## ALTOONA CITY PLANNING COMMISSION

Regular Meeting of Tuesday, September 12, 2023 at 3:00 PM  
4<sup>th</sup> Floor City Hall Common Room

At the request of the City of Altoona, we have completed our review of the land development plan for the above-referenced project. The following information was provided to our office on 08/25/2023 for review of a land development located at 5200 6<sup>th</sup> Avenue in the City of Altoona, Blair County:

**SHEET TITLE:**  
**LIGHTING & LANDSCAPE PLAN**

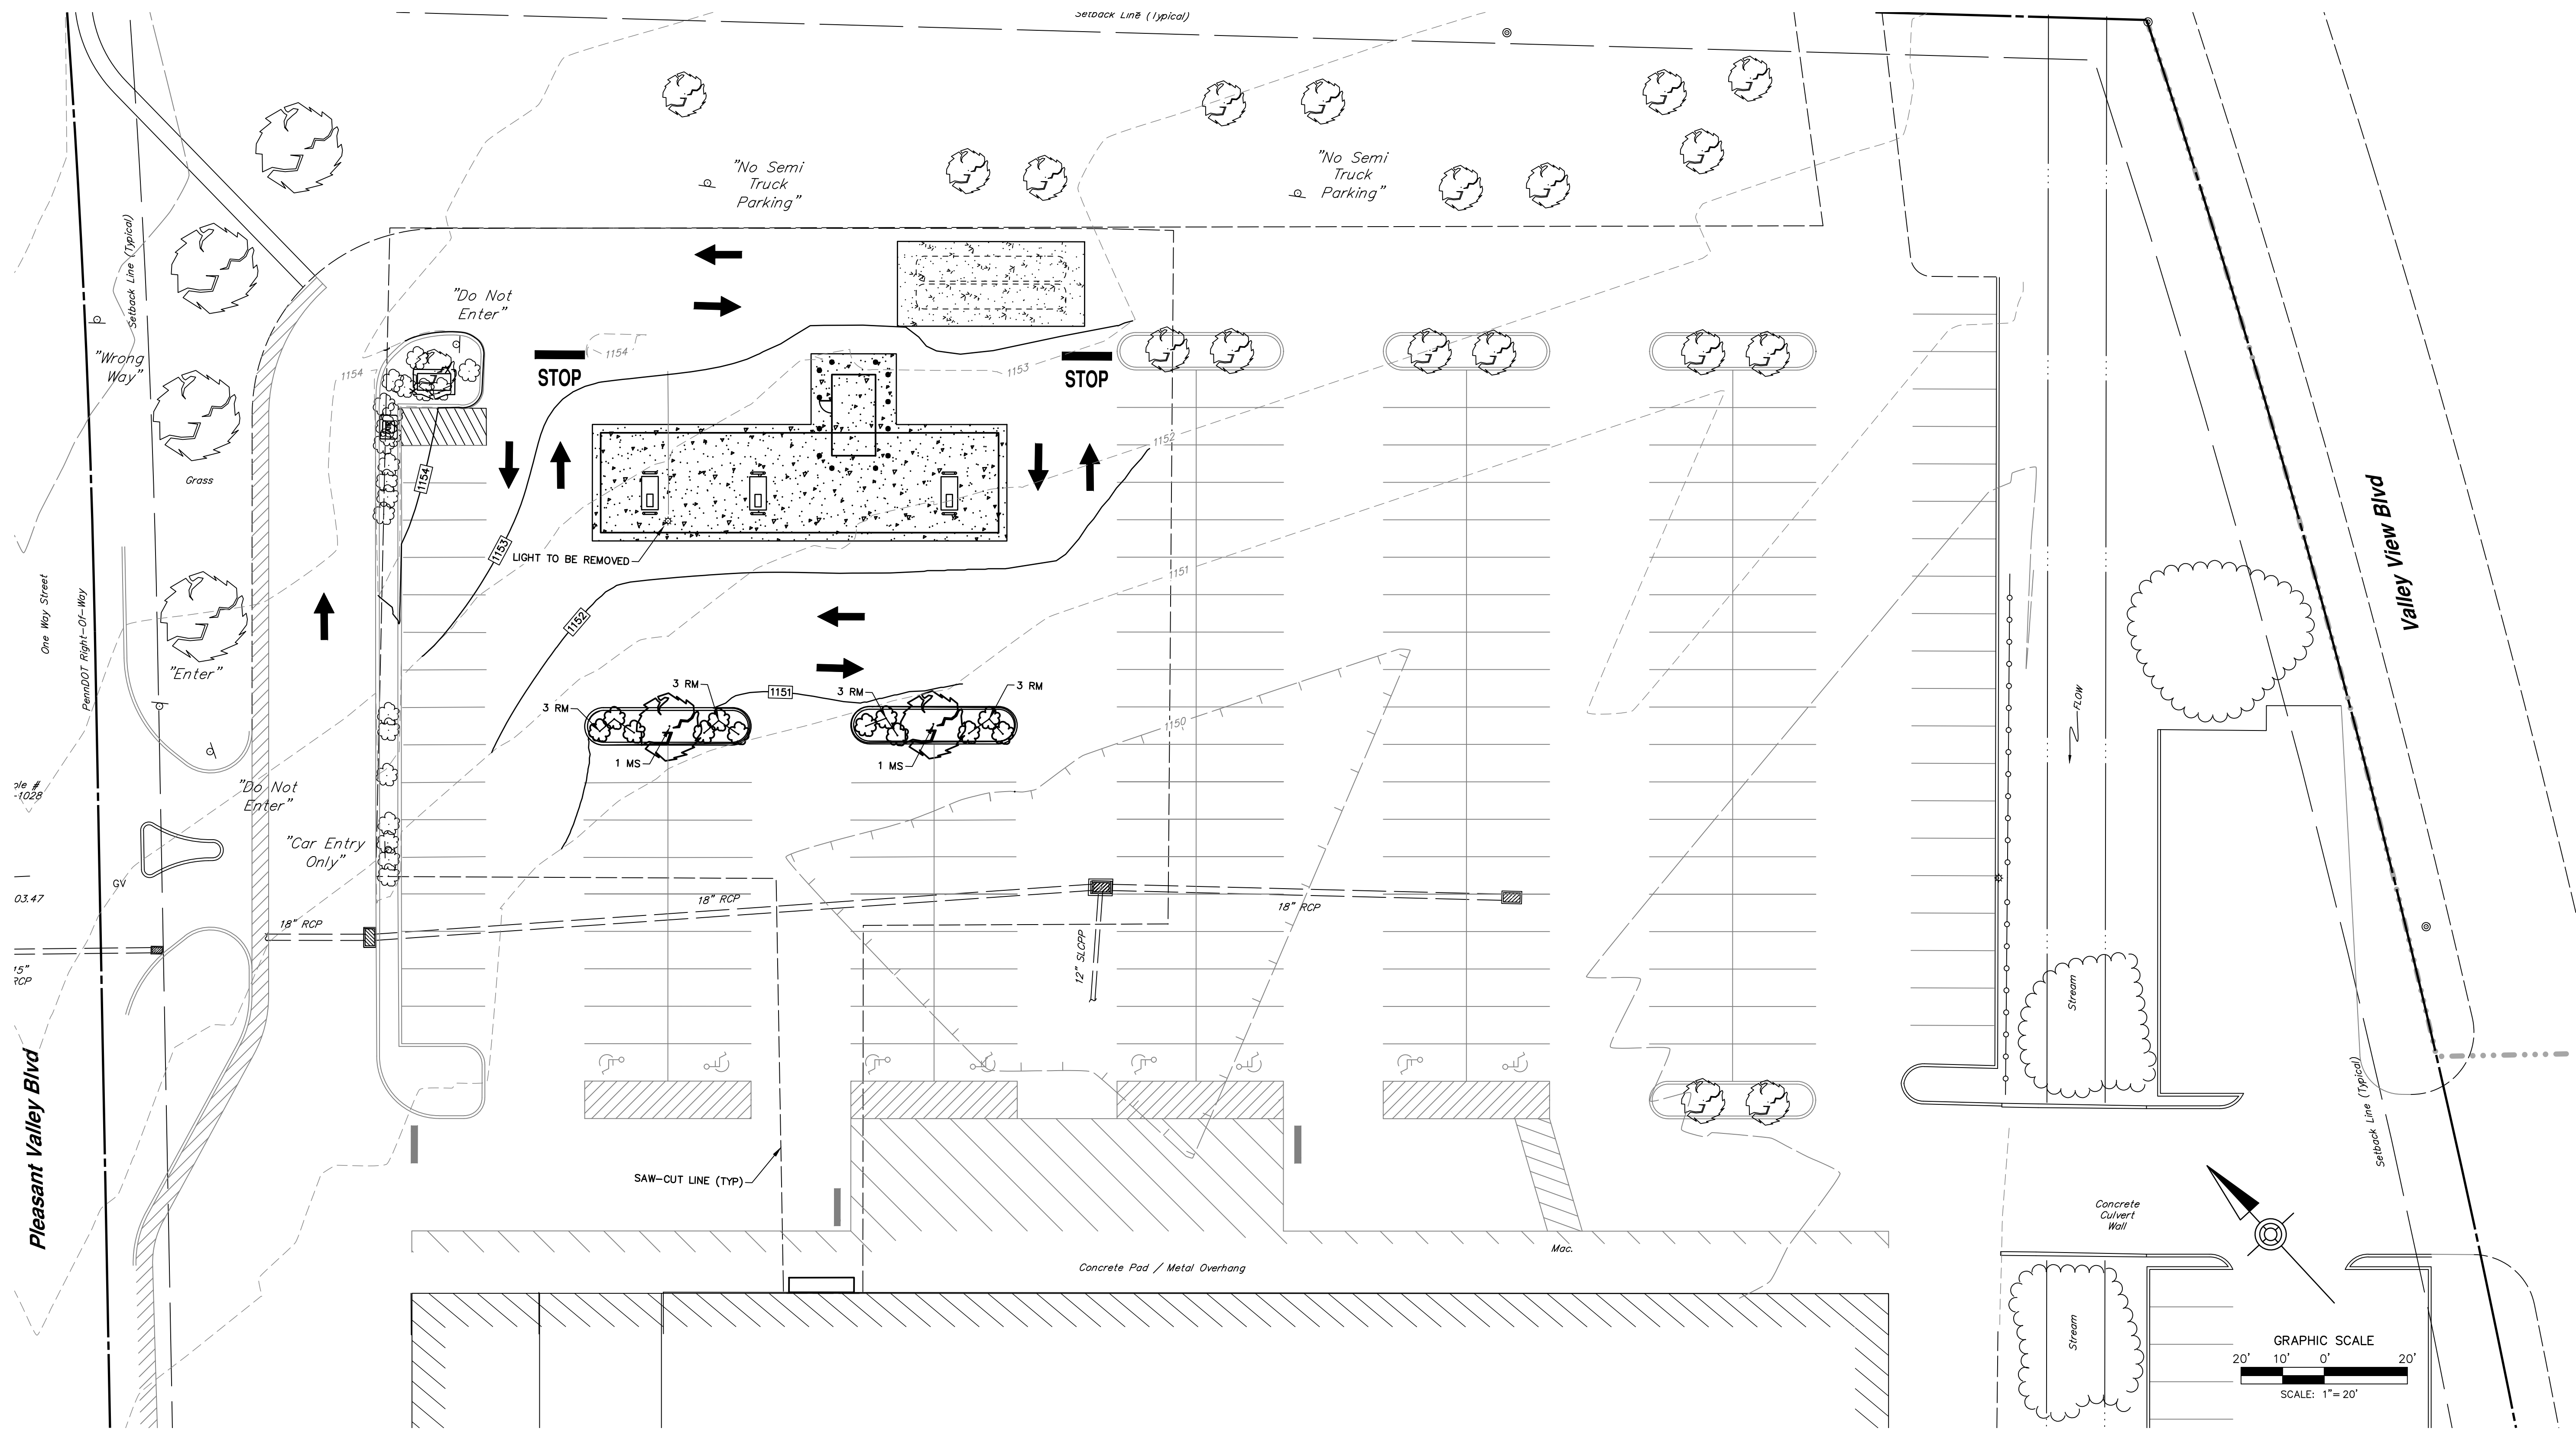
17. 640-58.Q. Location of all landscaping, including existing or proposed trees, shrubs, grass, mulched areas, etc. Size and type of plant materials shall be noted on the plan, and a planting detail showing how trees and shrubs are to be planted (size of hole, use of fill, stakes, wiring, etc.) shall be included. On Sheet 3, Landscaping Note 8 should be altered as per ordinance requirements. All islands require trees and shrubs and they are required to be maintained and replaced as necessary. A landscape plan should be included in the plan set. See additional comments below.

17. 640-58.Q. Location of all landscaping, including existing or proposed trees, shrubs, grass, mulched areas, etc. Size and type of plant materials shall be noted on the plan, and a planting detail showing how trees and shrubs are to be planted (size of hole, use of fill, stakes, wiring, etc.) shall be included. On Sheet 3, Landscaping Note 8 should be altered as per ordinance requirements. All islands require trees and shrubs and they are required to be maintained and replaced as necessary. A landscape plan should be included in the plan set. See additional comments below.

**A Landscaping Plan has been added to the set to show the location of all proposed landscaping. See LL-1, Sheet 10. The requested detail has been added to DT-1, Sheet 12 under "Tree Planting Detail". Note 8 on Sheet 3 has been modified to provide for the requirements above.**

**Lighting Notes to confirm compliance have been added to the Landscape and Lighting Plan LL-1 Sheet 10.**
